**ZONING AMENDMENT,  
PLANNING APPROVAL &  
SUBDIVISION STAFF REPORT****Date: October 4, 2012**

<b><u>NAME</u></b>	Benjamin P Cummings
<b><u>SUBDIVISION NAME</u></b>	951 Government Street Subdivision
<b><u>LOCATION</u></b>	951 Government Street (West side of Marine Street, extending from Government Street to Church Street)
<b><u>CITY COUNCIL DISTRICT</u></b>	District 2
<b><u>PRESENT ZONING</u></b>	B-1, Buffer Business District
<b><u>PROPOSED ZONING</u></b>	B-2, Neighborhood Business
<b><u>REASON FOR REZONING</u></b>	Changing market conditions
<b><u>AREA OF PROPERTY</u></b>	1 Lots / 1.4 ± Acres
<b><u>CONTEMPLATED USE</u></b>	<p>Subdivision approval to create 1 lot, Planning Approval to allow a self storage facility in a B-2, Neighborhood Business District, and Rezoning from B-1, Buffer Business District, to B-2, Neighborhood Business District, to allow a self storage facility.</p> <p><b>It should be noted, however, that any use permitted in the proposed district would be allowed at this location if the zoning is changed. Furthermore, the Planning Commission may consider zoning classifications other than that sought by the applicant for this property.</b></p>

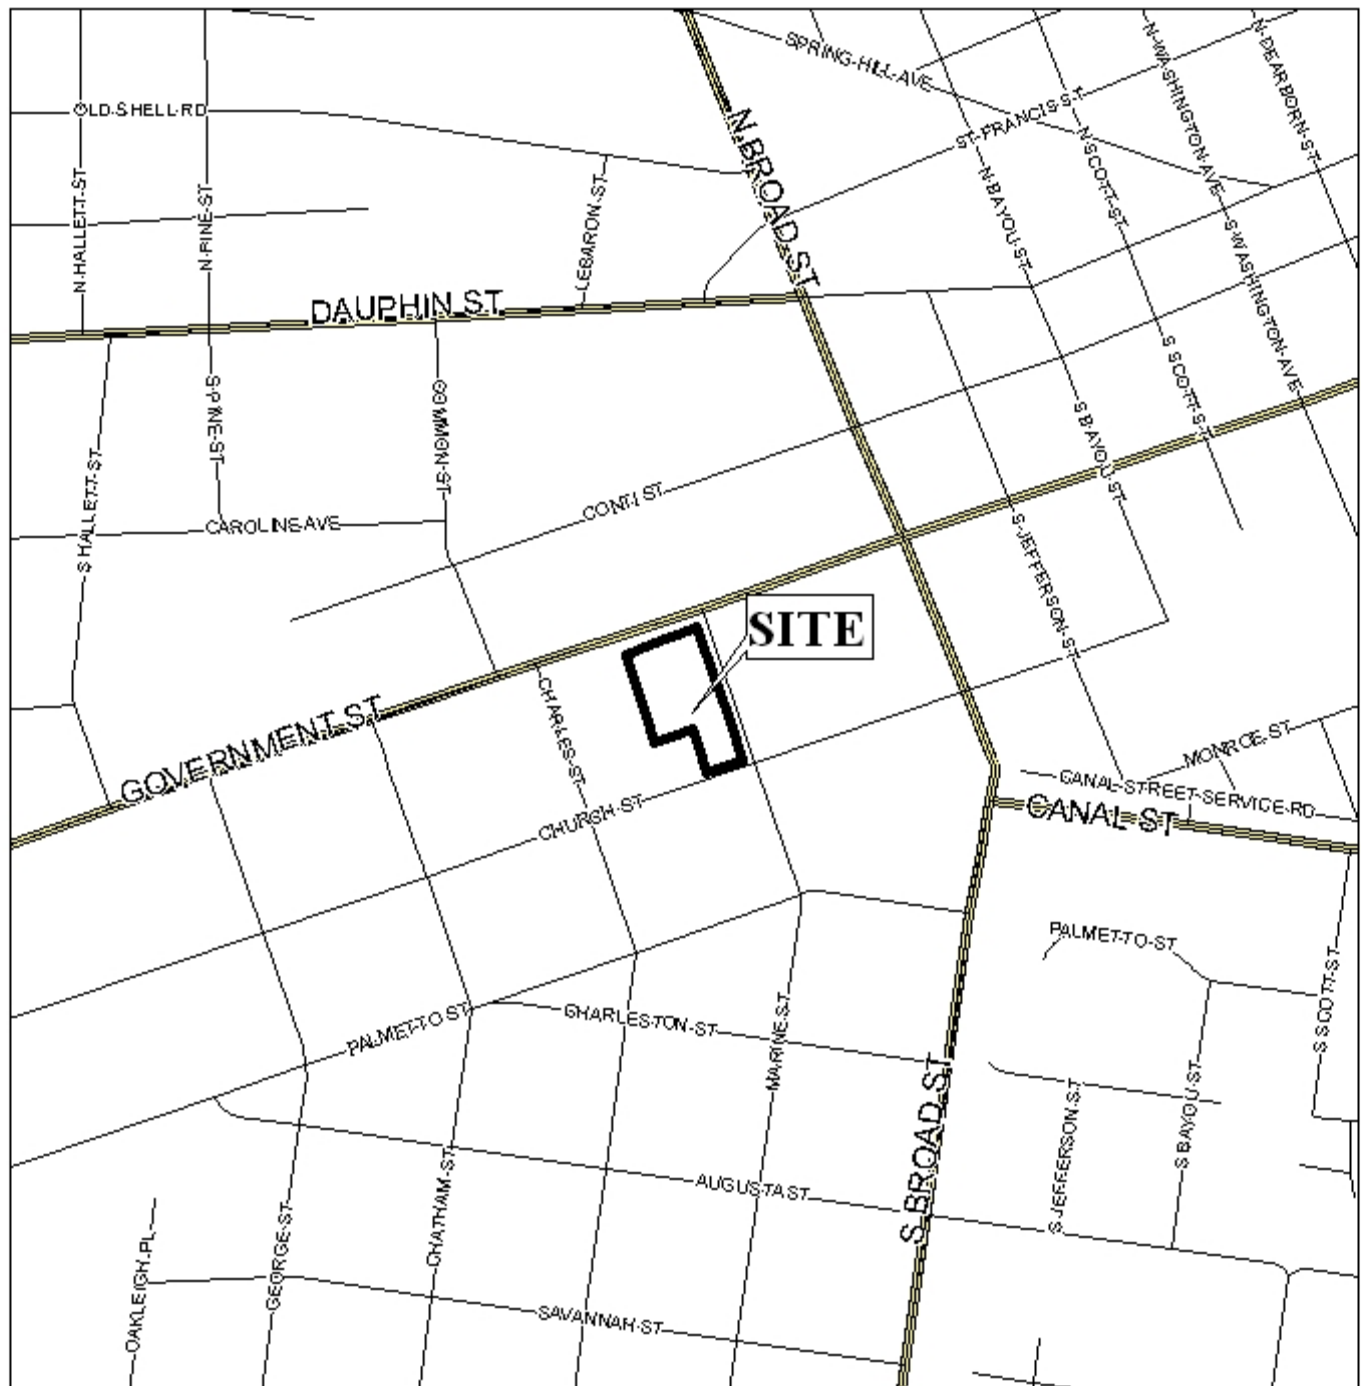
**Rezoning:** *The rezoning request is recommended for Denial for the following reasons:*

- 1) The applicant has not adequately shown that there are changing conditions in a particular area make a change in the Zoning Ordinance necessary and desirable;*
- 2) The applicant has not adequately shown that there is a need to increase the number of sites available to business or industry;*
- 3) The requested rezoning would not be consistent with the Government Street Zoning Study from 1984; and*
- 4) The proposed use would not be consistent with the mixed-use and residential vision of the site recommended by the findings of the New Plan for Mobile, adopted in January 2012.*
